Comments on Eversource's

“X-178-2 Transmission Line Rebuild and Optical Ground Wire Installation”

Above, construction plans for the X-178-2 Phase I, 2’ lidar-derived contour lines.

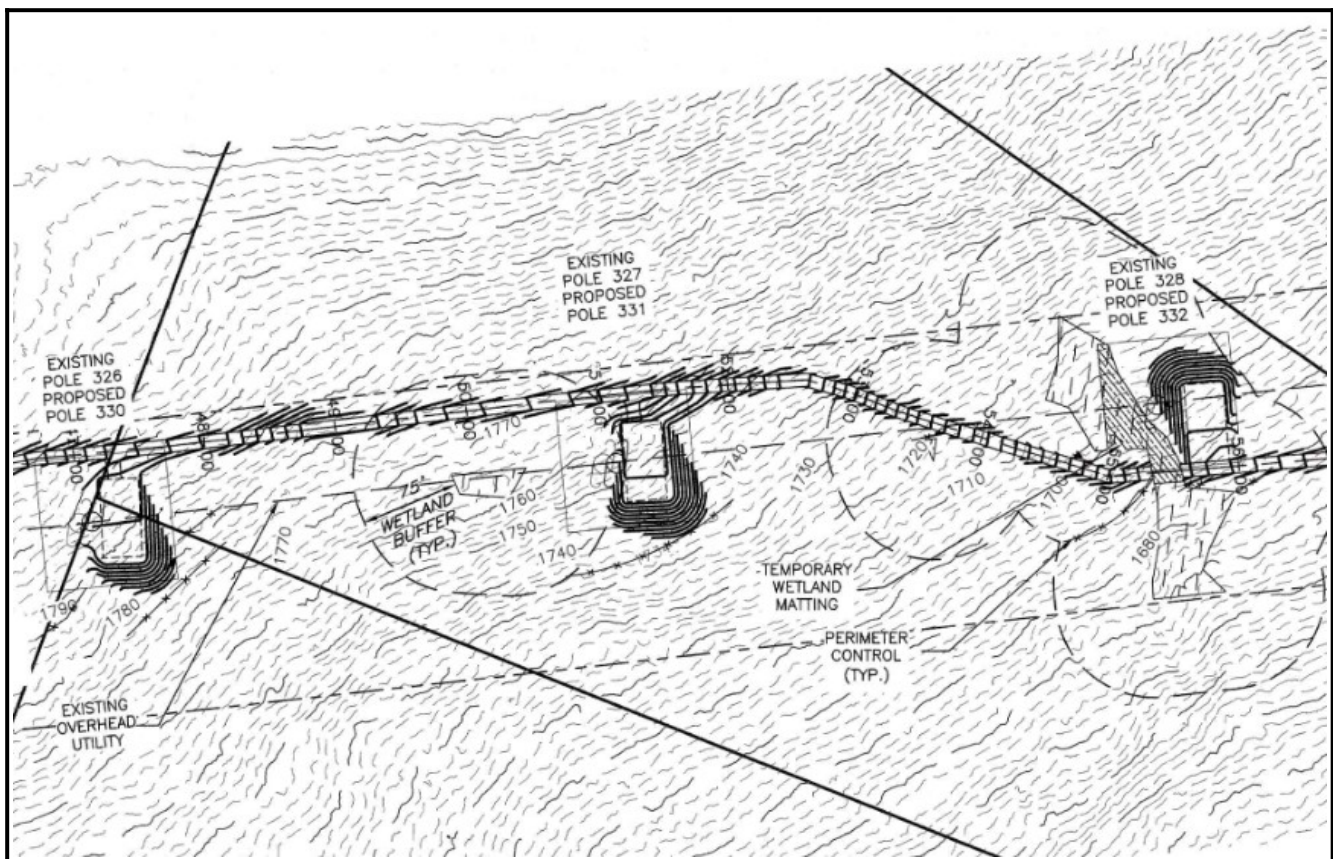
The Forest Service's project description fails to mention the crane pads, pull pads or road.

Given the extensive excavation, fill, and grading planned by Eversource, the Forest Service should title this project “X-178-2 Transmission Line Replacement, Optical Ground wire

102,000 linear feet of Optical Ground Wire [2] is presumably 9.6 miles, a figure that better conveys the extent of the proposed impacts of this project. The Forest Service should add “constructing 9.6 miles of 9” deep, 16-20’ wide permanent gravel heavy-equipment roads” or “constructing X miles of ... roads”, taking into account areas which would be accessed by helicopters rather than subjected to road building, which is in any case not permitted in this roadless area.

The Forest Service should add “construction/excavation of 140 (or 70 or less, where wetland matting is used) permanent 100’ x 100’ level crane pads at heights or depths of up to 20’ above or below the surrounding terrain.”

These construction plans, when released for the X-178-2 Phase II, which includes White Mountain National Forest, should be posted by WMNF with the other project documents.
